Aerospace Electronic Systems
Honeywell
One Technology Center
23500 W. 105th Street
Olathe, KS 66061
913 782-0400

Re: License No. 15-19986-01E

Honeywell International, Inc. would like to amend its NRC License No. 15-19986-01E to request a change to how we label our gas plasma displays.

information on the labels and change justification, including sign-off

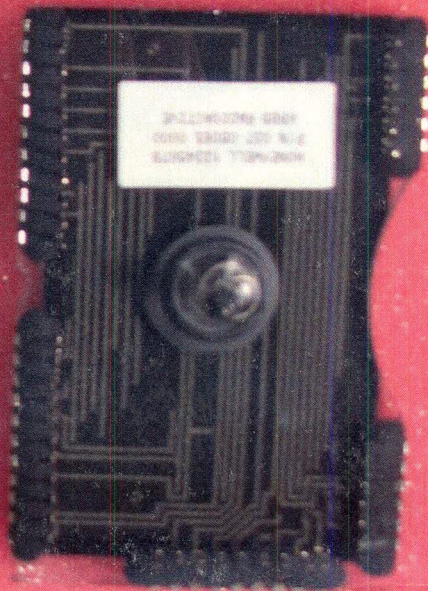
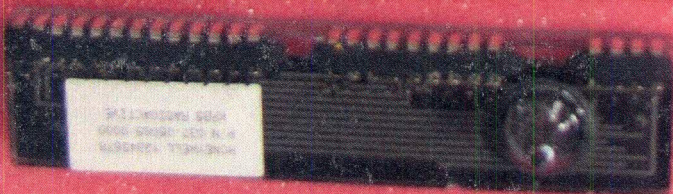
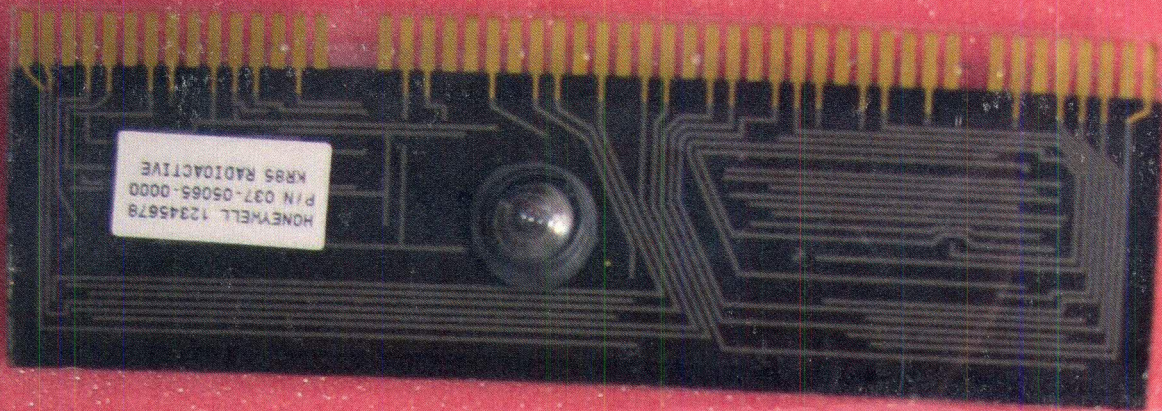
The following modifications to the labeling information placed on our gas plasma displays will facilitate compliance with ISO 2919, by adding the additional radioactive source information.

Currently the following identification is marked on each gas plasma display:

037-0XXXX-XXXX
YYWW
XXXX
Honeywell
OLATHE, KS KR85

The following modifications to this identification marking are requested:

Honeywell YYWWXXXX
037-0XXXX-XXXX
KR85 RADIOACTIVE

- 037-0XXXX-XXXX is the part number
- YYWW is the date code showing the year and week of manufacture
- XXXX is the 4 digit lot code
- Honeywell is the company name
- KR85 is the radioactive isotope
